Subject: Comments of the Public Advocates Office on Bear Valley Electric Service's

2023 to 2025 Wildfire Mitigation Plan and General Wildfire Mitigation

Docket: 2023-2025-WMPs

Figure 1.

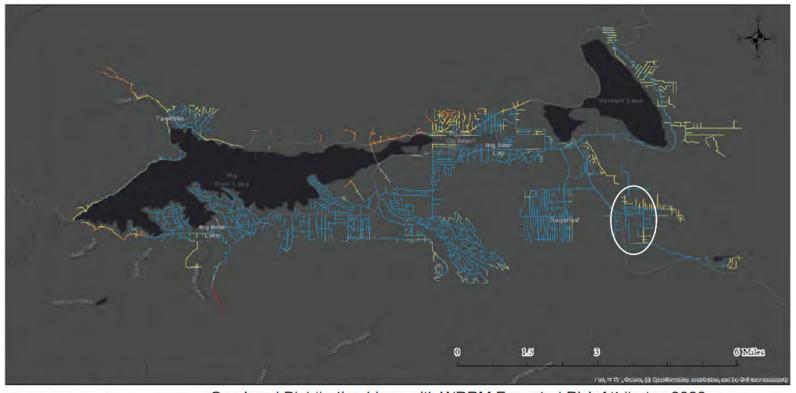
BVES's covered conductor workplans for 2023 and 2024 do not reasonably target the highest-risk locations identified by either the Fire Safety Circuit Matrix or the preliminary WRRM results. Specifically, less than two-thirds of BVES's planned miles are in the circuits considered high risk by BVES's own tool (the Fire Safety Circuit Matrix), and less than half of its planned miles are in the circuits considered high risk by Technosylva's model (the WRRM).

Figures 1 and 2 below show the approximate locations where BVES plans to install covered conductor in 2023 on its 4 kV distribution system and 34.5 kV sub-transmission system (respectively).¹¹ In both cases, BVES targets its covered conductor installations to areas that are primarily low or moderate risk, according to the WRRM. The white circles indicate the areas where BVES plans to install covered conductor in 2023.

Having previously directed BVES in this regard, Energy Safety should now require BVES to revise and resubmit its 2023 WMP to aggressively target system hardening plans to the highest risk locations of BVES's system. BVES should focus its near-term efforts on the riskiest 35 bare overhead miles (approximately 20 percent of BVES's bare overhead system¹⁹), as determined by the WRRM.²⁰ In its revised 2023 WMP, BVES should provide an updated 2024 covered conductor workplan that prioritizes at least 80 percent of BVES's planned system hardening in this riskiest tranche of its system.²¹ Energy Safety should additionally require BVES's revised 2023 WMP to include a preliminary workplan for 2025 covered conductor installation that similarly targets the highest-risk locations.
